From: Gordon Stansbury <gtsconsulting@twcny.rr.com>
Sent: Friday, February 4, 2022 11:11 AM
To: 'Parmley, Elizabeth (DOT)'; 'Deep, Jeffrey (DOT)'
Cc: John O'Brien
Subject: Traffic Impact Study Scoping - District East - Shopping town Mall Redevelopment
Attachments: Proposed Traffic Study Scope - District East - Shoppingtown Mall Redevelopment - Dewitt.pdf

Proposed Traffic Impact Assessment Scope of Work – Proposed District East Development Former Shoppingtown Mall – Town of DeWitt, NY

DISTRICT EAST MASTER PLAN

Sheet Number:	S-1
Sheet Name:	SITE PLAN
Scale:	N.T.S.
Date:	JANUARY 17, 2022

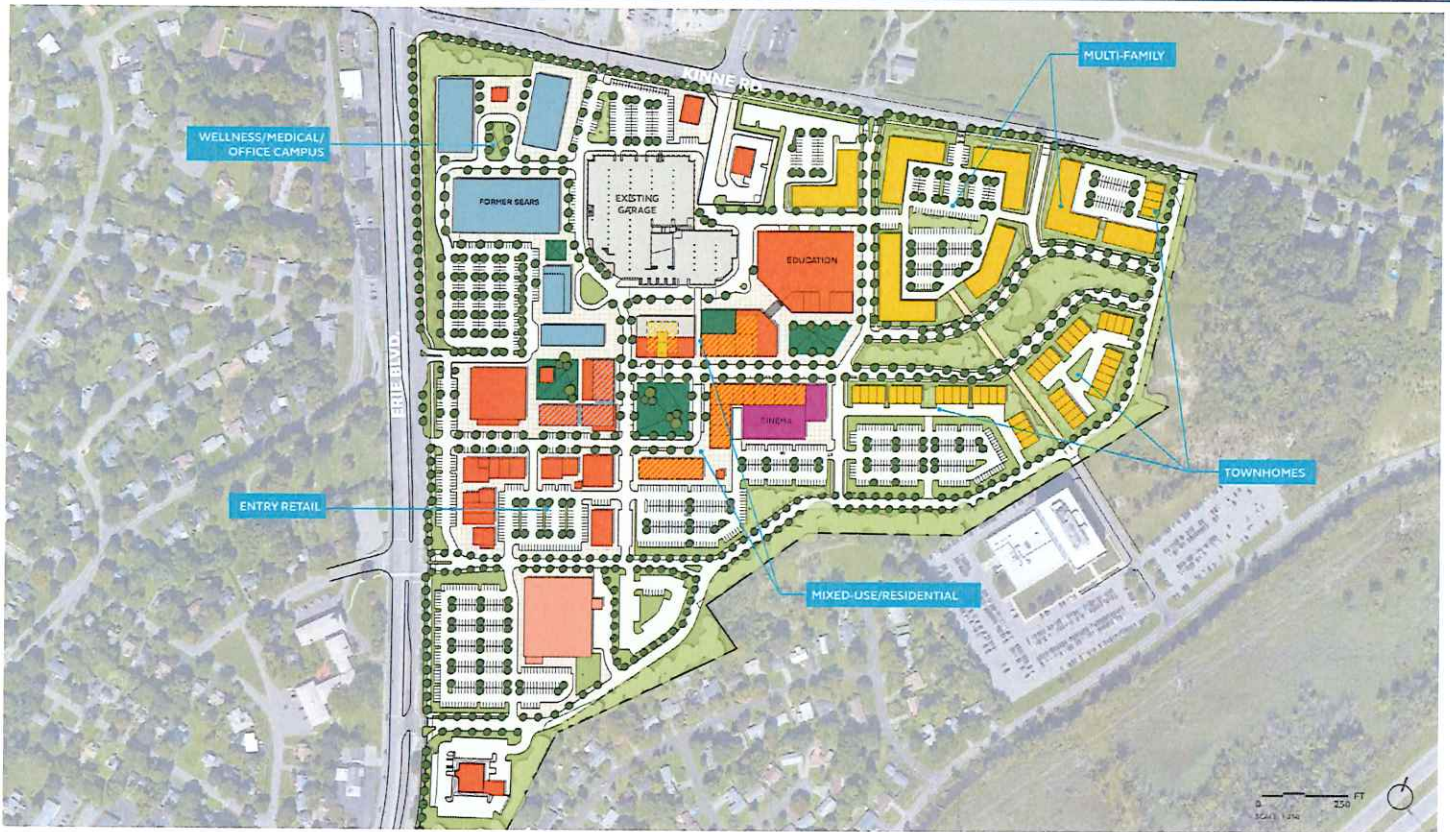
Thank you for reaching out early in the planning. Considering the size of the development, we'd like more information before determining the study area. SMTC demand modeling will need to be consulted and trip generation information provided for our review to better understand the magnitude of the development and possible impacts to the surrounding area.

Our preliminary comments on the TIS scope:

1. Study area:
 - a. Include E. Genesee @ Pickwick Rd.
 - b. Include Kinne Rd @ Butternut Dr and Towpath.
 - c. Additional intersection may be required.
2. PSAP Corridor improvements which are to be constructed this summer need to be incorporated into the future build models.
3. In addition to comparing to the existing conditions, the TIS should also compare as if the mall is fully occupied since there is mitigation already in place around the property.
4. The conceptual plan shows two new access points on Erie Blvd; only the one new right-in right-out is mentioned in the scope. In general, the Department is not in favor of additional access to Erie Blvd; it creates additional conflict points for both vehicles and pedestrians. The TIS should show why this access is beneficial to the State's road network/intersections.

Thank you for the information. We believed the ITE Trip Gen numbers for the existing mall size are very conservative compared to what the mall was or would be generating. Considering this and without having actual historic information to compare, we won't require a comparison or analysis of the mall as if it was fully operational.

We have no additional requirements for the TIS limits, summarized below:

- E. Genesee @ Pickwick Rd.
- Kinne Rd @ Butternut Dr and Towpath.
- Erie Boulevard @ East Genesee Street
- Erie Boulevard @ Southern Access
- Erie Boulevard @ Grenfell Road / Northern Access
- Erie Boulevard @ Kinne Road
- Kinne Road @ Post Office Driveway / Right in Only Access
- Kinne Road @ Widewaters Road / Site Access
- Butternut Drive @ Agway Drive
